JOONDALUP DESIGN REFERENCE PANEL NOTES OF MEETING HELD ON 18 NOVEMBER 2010

ITEM 1 PROPOSED HOSPITAL OFFICES AND SHOP AT LOT 1 (113) GRAND BOULEVARD, JOONDALUP

East Elevation

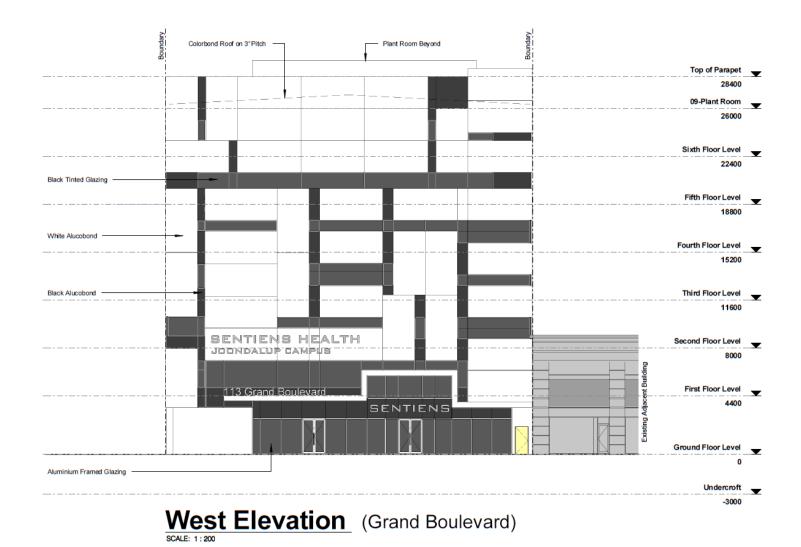
- Noted that the facade was bland in design, and had concerns with the amenity and shading of the building.
- Queried the elevation and appropriateness of the building.

North Elevation SCALE: 1:200

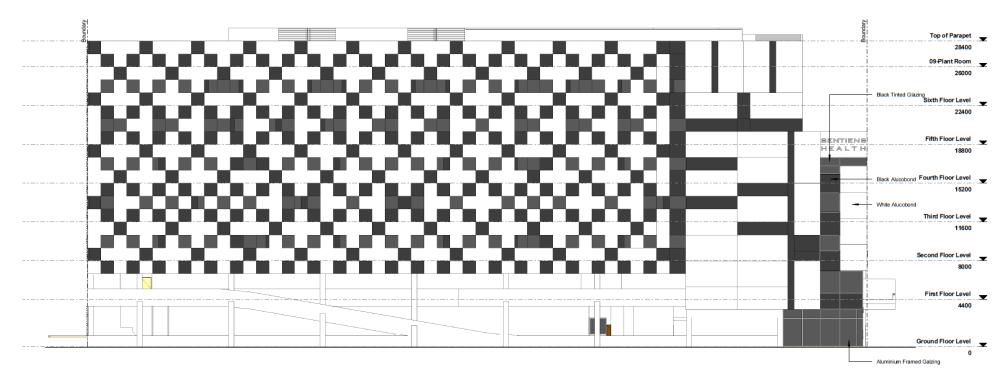
- Sustainability and green star rating, in relation to the type of glass used on the North elevation. Project is targeting 4.5 star NABERS rating.
- Location of bin store for medical wastes and laundry pickup/delivery.

- That the North elevation was relying on facade treatment and pattern, rather than dealing with the lack of articulation in the design.
- West elevation was not inviting in design from primary street (Grand Boulevard), considered bulky and imposing with no articulation. Needs further consideration.
